Taylor Canyon Elementary Building Demolition

Addendum #1

RFP 23-001

ADDITIONAL BASEMENT STORAGE AREA
 OAK ELEMENTARY SCHOOL
 OGDEN CITY SCHOOL DISTRICT

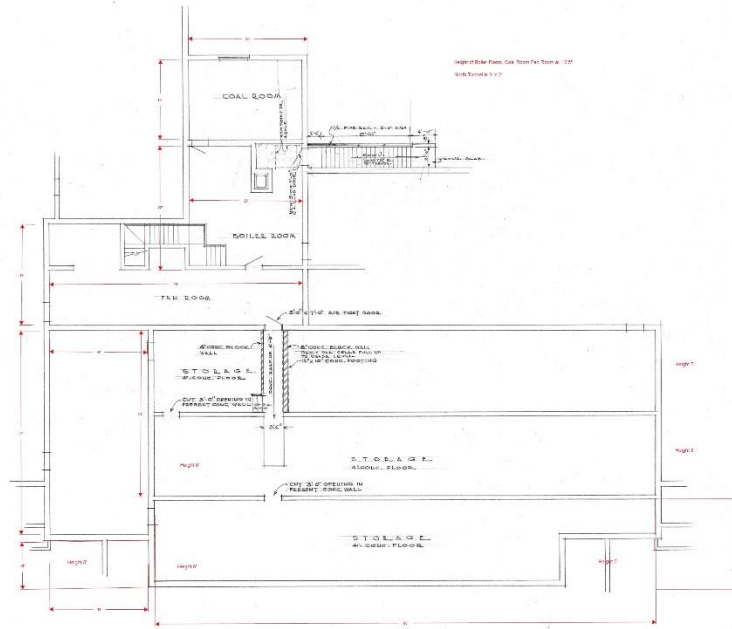
Everything on north side is 3' x 3' tunnel
 Every Tunnel on the South Side is 35' wide
